Deadline 6 - Representation

Kent Street Passing Places and traffic Management Plan

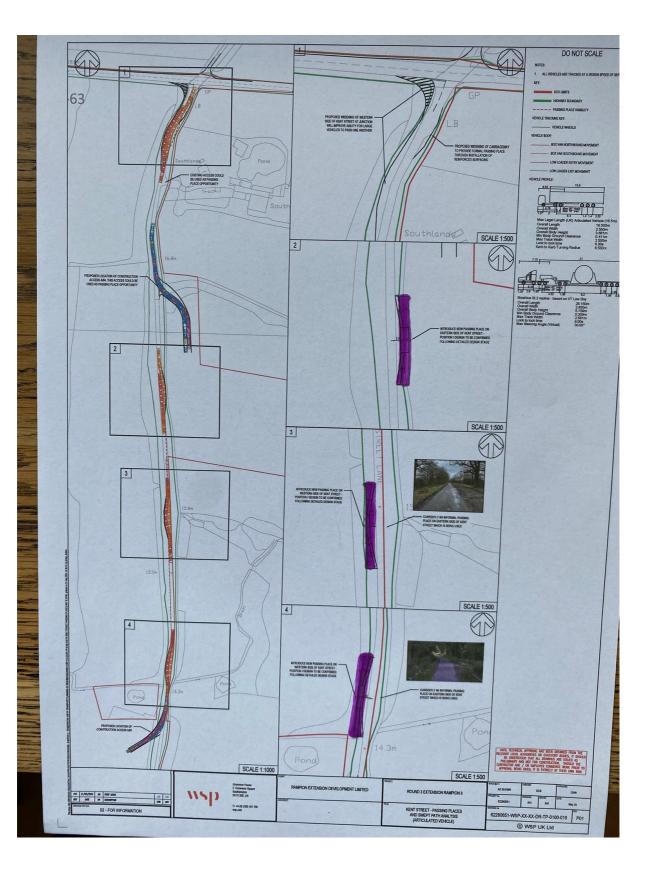
This survey shows that the latest drawings of the widths and sizes of these places is not accurately depicted on the Applicant plans.

As you can see from the drawing below and the dark rectangles on the right hand side, the actual parking places are much larger and destructive than the Applicant's current vectors and measurements which do not accurately depict the real effects along Kent Street.

- Passing places larger than shown on plans as need to be 3m wide and same size of a rectangle, not as per vectors on current plan
- 3 x completely new passing places on the west of Kent Street, worst side for views into the substation site

- Kent Street only thought about towards the end of the process as DCO boundary tight to the east of Kent Street hence not able to use existing passing places on the east

- Increased destruction of hedges and trees not currently accounted for in proposals due to buildability and widths of passing places, at least 4 more mature oaks tree root protection areas to be affected

- Overall buildability of these passing places, widths needed for diggers to build 3m wide passing area. As with any digging or foundation work they would need at least 3m wide perimeter around the passing place to be able to construct the new road, lay pipes etc. This would take the area destroyed into the hedge line of Kent Street east, leaving open views into the substation site. Also pipes over ditches and current fall for water to streams, build- up of road over pipe to take heavy lorries – complex construction, would Kent Street need to be closed just to build passing places?

- Overall negative affect on rural character of the lane to be increased from current proposals
